Access Compliance Report

Public Rights-of-Way

(Curb Ramps)

Intersection ID: 6121	Main Street: AMHERST_GLEN_DR	Cross Street: ATKINS_RIDGE_DR	Location:	N
ADA ID: 046F07129E0D	Ramp Type: Perp	Initial Pass/Fail: Fail	Overall Compliance: No	Severity Score: 12.5
Codes/Mitigation Info/Possible Solution		Field Measurements/Component Compliance

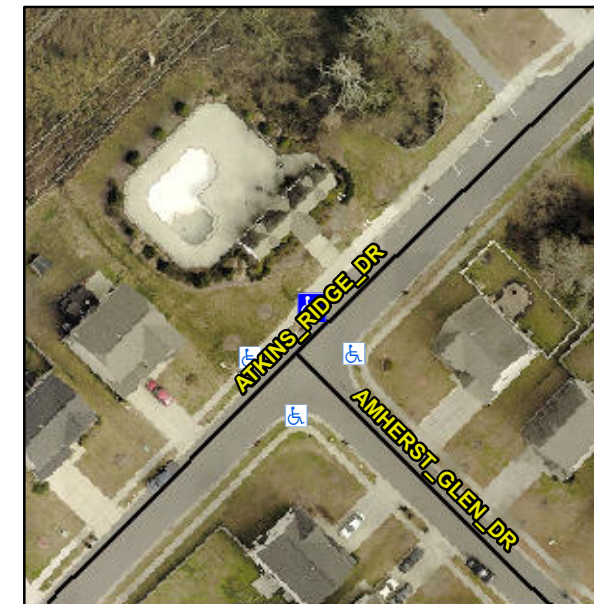
Not Found, R304.2.2

Compliance	Description	Data	Compliance	Description	Data
N/A	Ramp Length (in)	61.0	No	Ramp Slope (%)	8.9
Yes	Ramp Width (in)	48.0	Yes	Ramp XSlope (%)	0.4
N/A	Flare Type LT	N/A	N/A	Flare Type RT	N/A
N/A	Flare Slope LT (%)	N/A	N/A	Flare Slope RT (%)	N/A
N/A	Flare Traversable LT?	N/A	N/A	Flare Traversable RT?	N/A
N/A	Landing Length (in)	N/A	N/A	DWS Provided?	N/A
N/A	Landing Width (in)	N/A	N/A	DWS Contrast?	N/A
N/A	Landing Slope (%)	N/A	N/A	DWS Length (in)	N/A
N/A	Landing X Slope (%)	N/A	N/A	DWS Full Width?	N/A
N/A	Landing Curb? (Y/N)	N/A	N/A	DWS Offset (in)	N/A
N/A	Shared Landing?	N/A			
N/A	Gutter Ponding?	N/A	N/A	Gutter Slope (%)	N/A
N/A	Gutter Lip Ht (in)	N/A	N/A	Gutter X Slope (%)	N/A
N/A	Painted X Walk1?	No	N/A	Painted X Walk2?	N/A
	X Walk 1 Direction	To SE		X Walk 2 Direction	N/A
N/A	X Walk 1 Width (in)	N/A	N/A	X Walk 2 Width (in)	N/A
	X Walk 1 Slope (%)	2.7		X Walk 2 Slope (%)	N/A
	X Walk 1 X Slope (%)	0.3		X Walk 2 X Slope (%)	N/A

Remove & Replace Entire Ramp.
